SERVICE BULLETIN

M-929

LATE 1986 REAR FORK PIVOT SHAFT — ALL FLT/FXR MODELS

Figure 1. Rear Fork Pivot Shafts Comparison

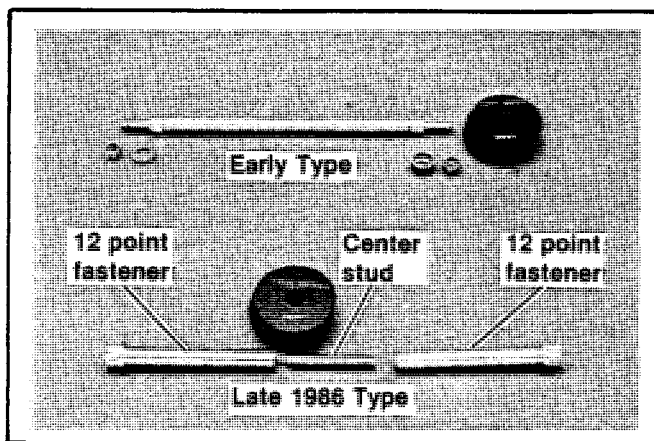
See Figure 1. The FLT/FXR rear fork pivot shaft was changed on late 1986 models. Although the configuration has changed, the function is the same.

The type of pivot shaft can be identified by removing the frame bracket chrome plugs. The new pivot shaft has a 12 point fastener at both ends and no washers.

1. There are no flats on the new shaft fasteners to register with the rubber mounts.
2. After installation is completed, hold one side of the new pivot shaft and tighten the other side to a torque of 55 ft-lbs.
